Appendix B.1.c - LNA Email

RE: RHR Apex Plant Update

**RE: Lhoist North America of Arizona, Inc. – Apex Plant
Comments on Draft 2021 Regional Haze Four Factor Review and Initial Control
Determination**

Pilot Peak Plant Reasonable Progress Control Determination

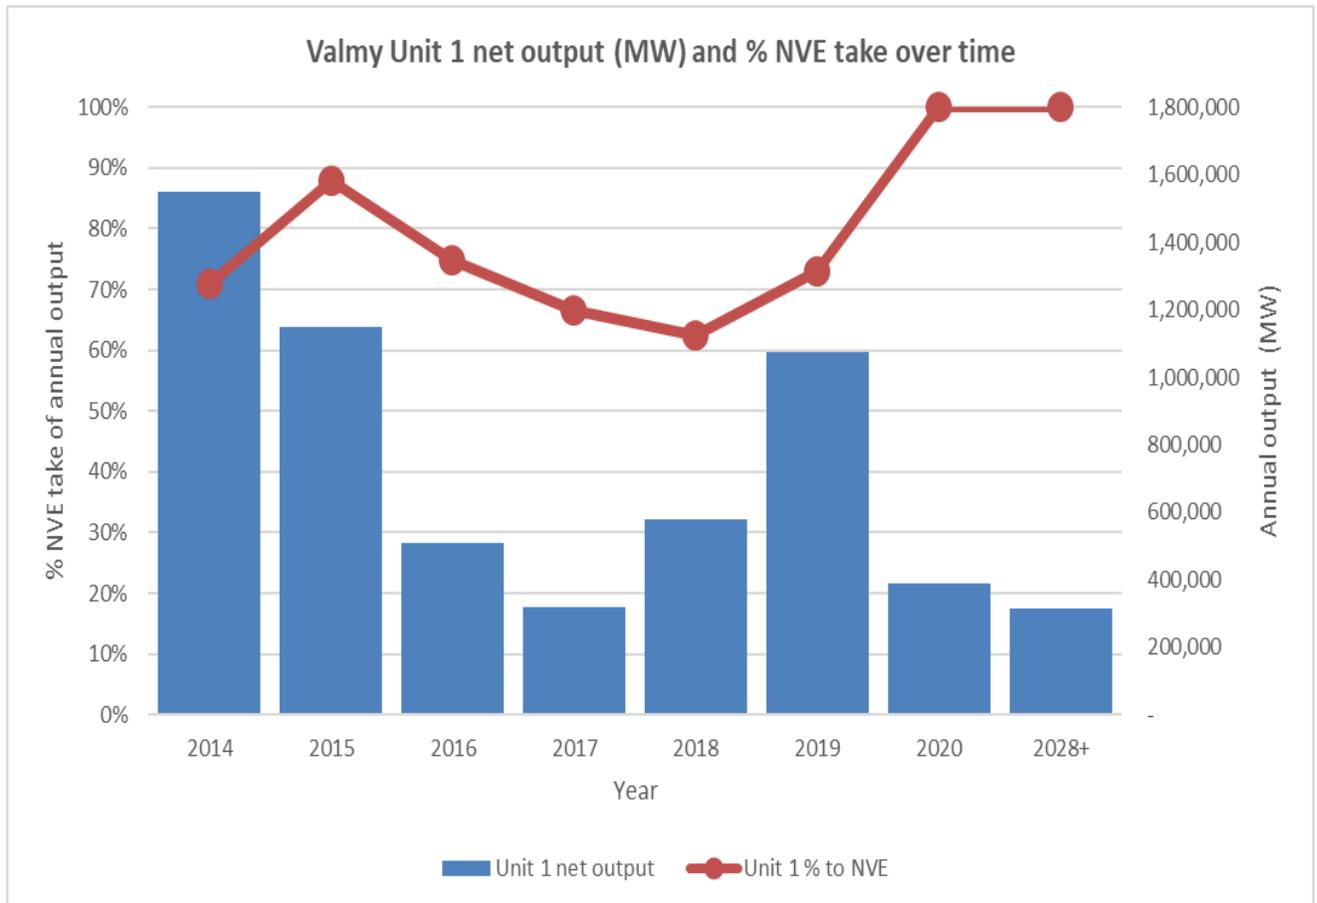
continuous compliance with the opacity limit on Unit 1 if the sodium-based sorbents needed to control SO₂ emissions were employed.

The S&L study on the use of DSI on Unit 1 recommended that activated carbon be injected in conjunction with the use of DSI for SO₂ control. The cost of including activated carbon injection equipment was therefore included in the estimated capital cost associated with this alternative that we provided with our previous response.

North Valmy Question (b) Increase of Utilization/Emissions in 2019 at Unit 1

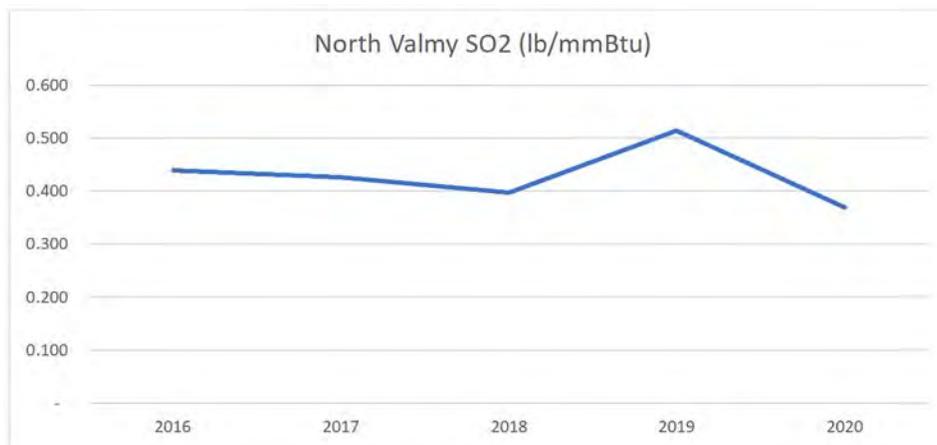
A(b)(1) In 2019 there was a slight increase in NVE's proportional take of the output from Unit 1 as compared to 2018 as NDEP has observed. However, a review of historical data shows that NVE's output take has typically fluctuated +/- 15% year over year. For example, the 2015 year shows a higher percentage of NVE take than in 2019, as shown on the chart below.

While many factors contribute to the reasons behind the year-over-year fluctuation in output take by NVE/IPC, the subject is now no longer relevant because Idaho Power completed their exit from their share of Unit 1's output on December 31, 2019. All of Unit 1's operation in 2020 was taken 100% by NVE, and all ensuing operation until the unit's eventual retirement will continue to be taken 100% by NVE.

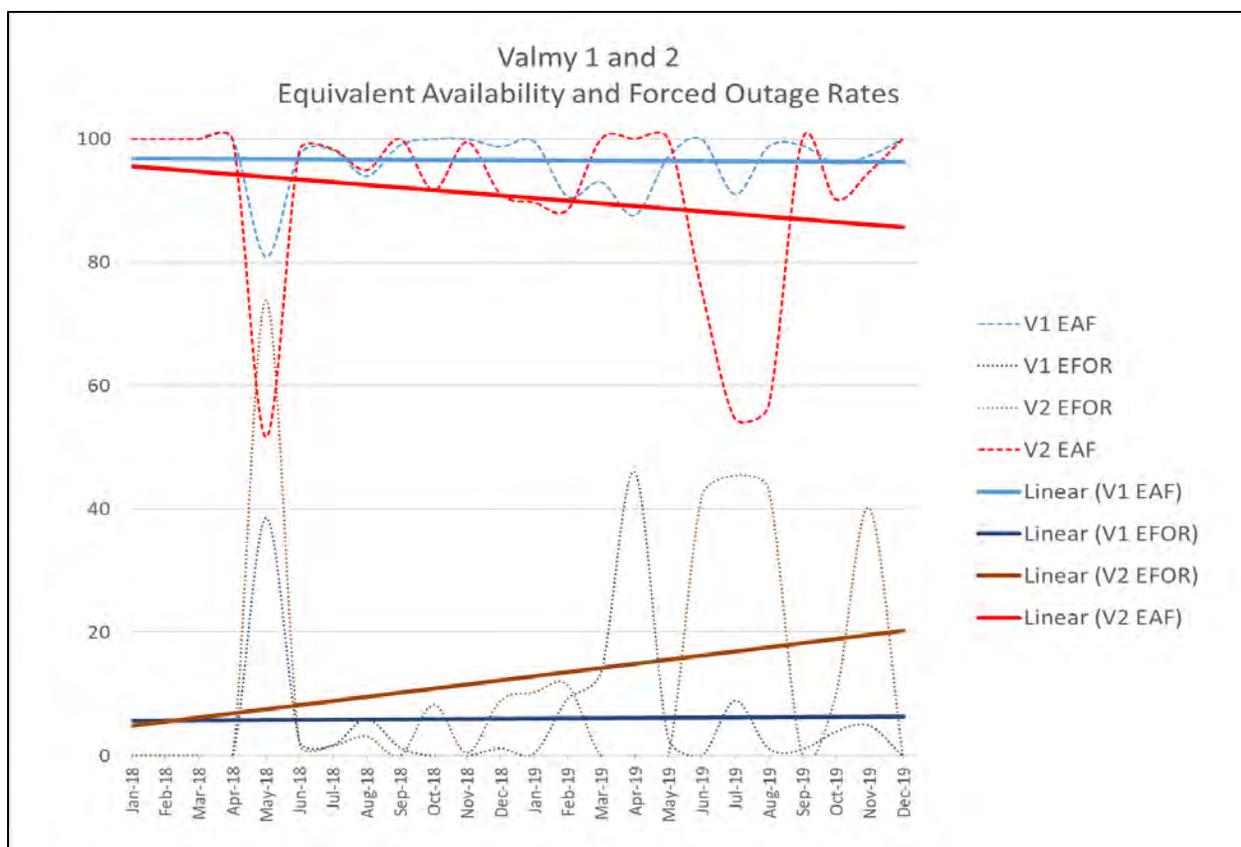
Q(b)(2) The chart below shows that, not only did SO₂ emissions increase due to increased utilization in 2019, but SO₂ emissions also increased. A review of unit-specific capacity factors shows that load was shifted to the uncontrolled Unit 1 in 2019 instead of the controlled Unit 2. Why?

A(b)(2) As described in a previous response to NDEP's questions in the report dated January 15, 2021, the North Valmy Station experienced an extended run during 2019 due to a combination of factors including the high gas prices in the northwest as well as transmission reliability in the region. While both units were in demand during the year, Unit 2 experienced significant loss of capacity primarily due to scrubber pluggage, pulverizer problems, and several other operational constraints.

To expand on the topic in more detail, NVE has developed a visual representation of North Valmy's equipment availability and forced outage over the 2018-2019 period in the chart on the following page using data from the North American Electric Reliability Corporation (NERC) Generating Availability Data System (GADS), or NERC-GADS. The NERC-GADS data is a mandatory industry reporting program required for conventional generating units 20 MW and larger. The objective of the reporting program is to provide compilation and maintenance of an accurate, dependable, and comprehensive database capable of monitoring the performance of electric generating units and major pieces of equipment.

The chart shows the Equivalent Availability Factor (EAF) and the Equivalent Forced Outage Rates (EFOR) for Units 1 and 2 for this 2018-2019 period. EAF is the fraction of a given operating period in which a generating unit is available without any outages and equipment or seasonal deratings. EFOR is the hours of unit failure (unplanned outage hours and equivalent unplanned derated hours) given as a percentage of the total hours of the availability of that unit (unplanned outage, unplanned derated, and service hours).

In the chart above, note the solid light and dark blue trend lines showing a consistently very high EAF and a very low EFOR for Unit 1 over the time period. In contrast, note the solid red and brown trend lines for Unit 2 showing decreasing EAF and increasing EFOR throughout 2019. These data support the conclusion that, among other reasons already described, Unit 2’s unavailability during periods of load demand in 2019 was a significant contributing factor as to why Unit 1 served a higher proportion of the station output during the year.

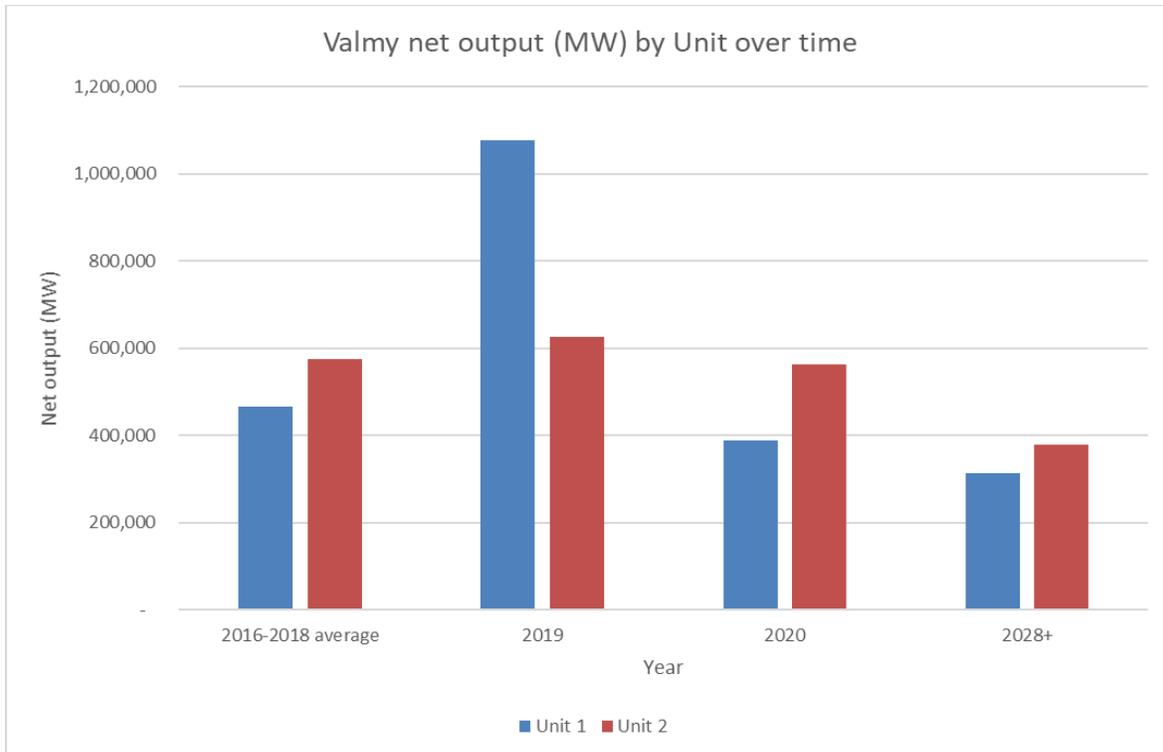
Q(b)(3) The latest response states “The output of North Valmy Unit 1 was also higher in 2019 due to Idaho Power’s exiting of their share of Unit 1’s output – an action that necessitated the consumption of the coal reserves for Unit 1 that had previously been purchased by Idaho Power.” If this is the reasoning for this, please provide more narrative and documentation for it. However, more explanation is needed as to why the uncontrolled unit was used more instead of the controlled unit (referring to NVE’s portion only) and why it’s unreasonable to anticipate the same occurrence in future years.

A(b)(3) As discussed above as well as in previous responses, there were several factors that in combination led to Unit 1 operating more than Unit 2 during 2019. However, Unit 1’s operation in 2019 in particular is an anomaly when compared against recent trends (2016-2018 baseline period); this distinction is further illustrated when compared against the most recently available operating data for year 2020, as displayed in the chart below.
